8<sup>th</sup> December 2021

**RE: Curl Curl to Freshwater separated cycle path**

Figure 5:  
Configuration proposed for Option 1A, adjusted to meet TfNSW's recommended lane widths  
(Source: Northern Beaches Council)

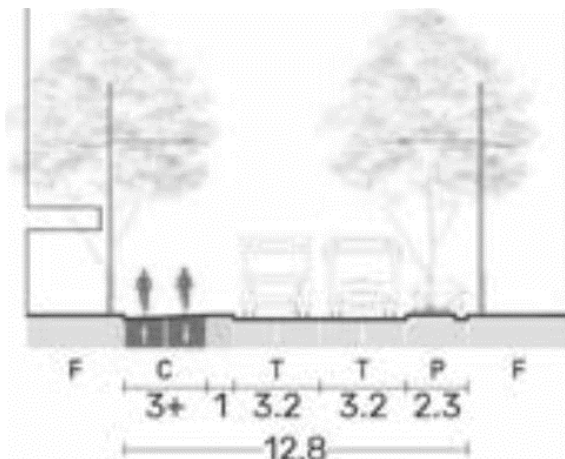
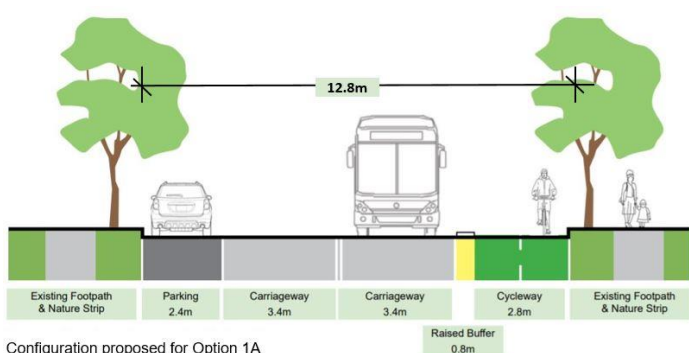
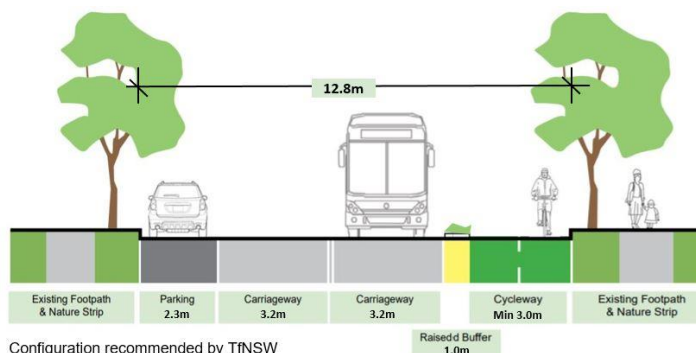
- **Option 1A is preferred, but with a 3.0m wide bicycle path.**

Option 1A will create a high-quality contribution to the Northern Beaches Safe Cycling Network. The wide bicycle path will encourage more bike riding and active travel, helping to meet Council's mode shift targets. However, we suggest adjusting the widths of the vehicle and parking lanes to create a best-practice 3.0m wide bike path with a 1.0m buffer. Figure 4 shows the configuration recommended by Transport for NSW for a 12.8m road. In Figure 5, these widths are applied to Oliver Street and presented alongside Council's proposal for Option 1A.

Configuration proposed for Option 1A  
2.8m separated bicycle path, 0.8m buffer

Configuration recommended by TfNSW  
Min 3.0m separated bicycle path, 1.0m buffer

Figure 6:  
Constrained configuration for a 12.8m carriageway, retaining parking on both sides of the road.  
Source: TfNSW Cycleway Design Toolbox, p.32)

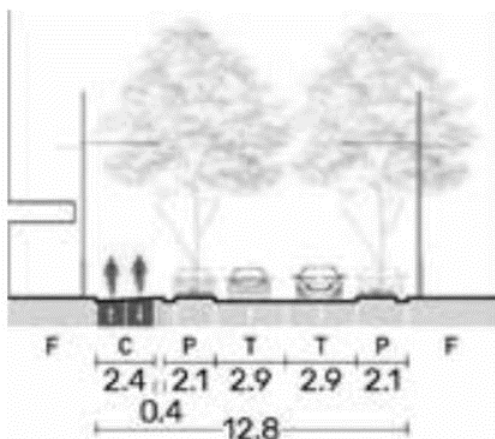
Where buses do not pass regularly, it may be possible to retain parking on both sides of the road and create an adequate bicycle path by narrowing the vehicle and parking lanes. The Cycleway Design Toolbox suggests the configuration shown in Figure 6 to achieve an acceptable 2.4m bicycle path with a 40cm buffer. Figure 7 demonstrates how Option 1B could be adjusted to create the recommended layout.

Figure 7: Configuration proposed for Option 1B, adjusted to meet TfNSW's recommended lane widths (Source: Northern Beaches Council)

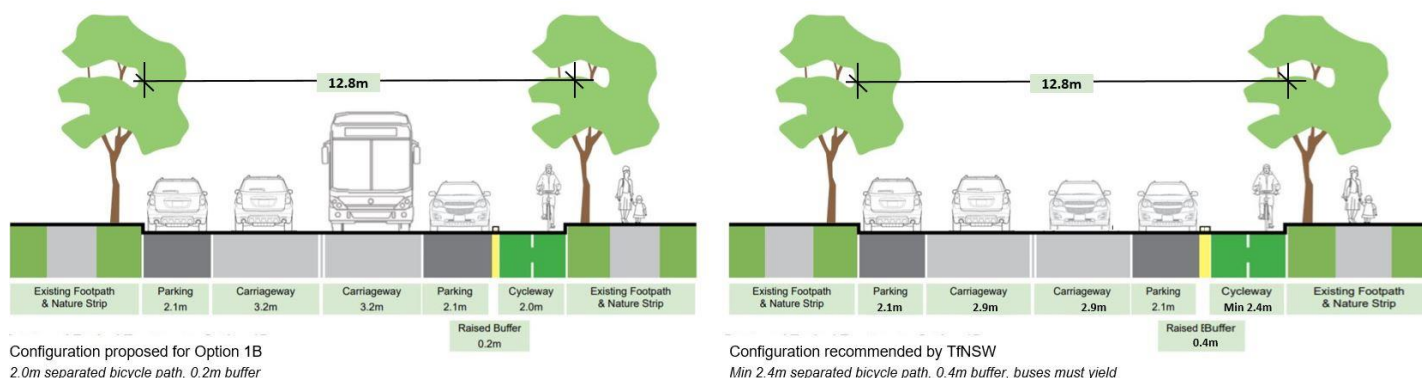
- **Option 1B could be considered for some sections, but with a 2.4m wide bicycle path.**

For the section of the Freshwater to Curl Curl route south of Wyndora Avenue, this treatment is worth exploring. Buses do not use the southern stretch of Oliver Street and the on-street parking is particularly valuable close to the shopping village, the weekend markets, the community centre and St John's Primary School.
